Technical Newsletter

No:
73

Subject:
Sand casted main cover on Minex, 8101

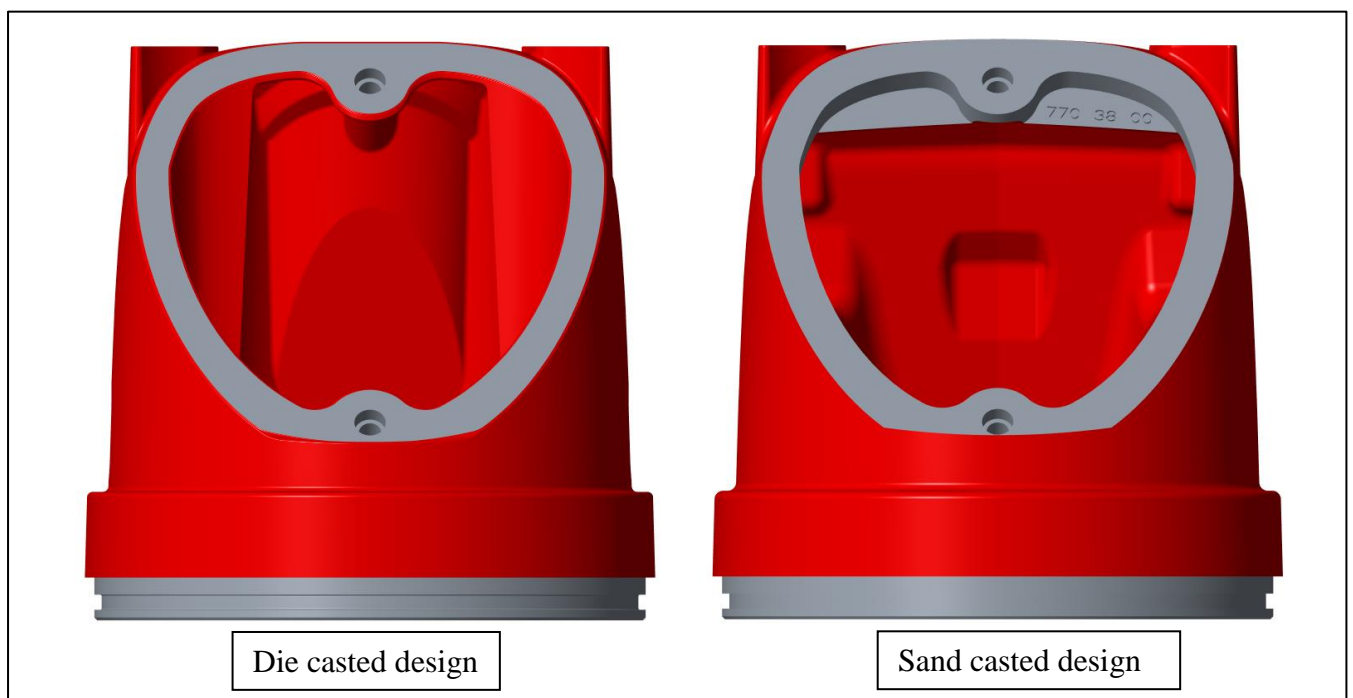
As one step to improve our delivery situation, with the purpose to come back to normal lead times of pumps, Grindex has decided to implement a sand casted main cover on Minex, 8101.

The main cover used so far has been die casted, and is seen to the left in the picture below.

The sand casted main cover will have a very similar design to the die casted cover, but the surface roughness will be slightly rougher and a marking "770 38 00" will be visible on the sand casted design, as seen in the picture above.

The Grindex part number 51 782 00 remains unchanged for both designs.

Both the sand casted and the die casted main covers will be in production in parallel.

Sand casted main covers will be implemented in the end of January 2018.
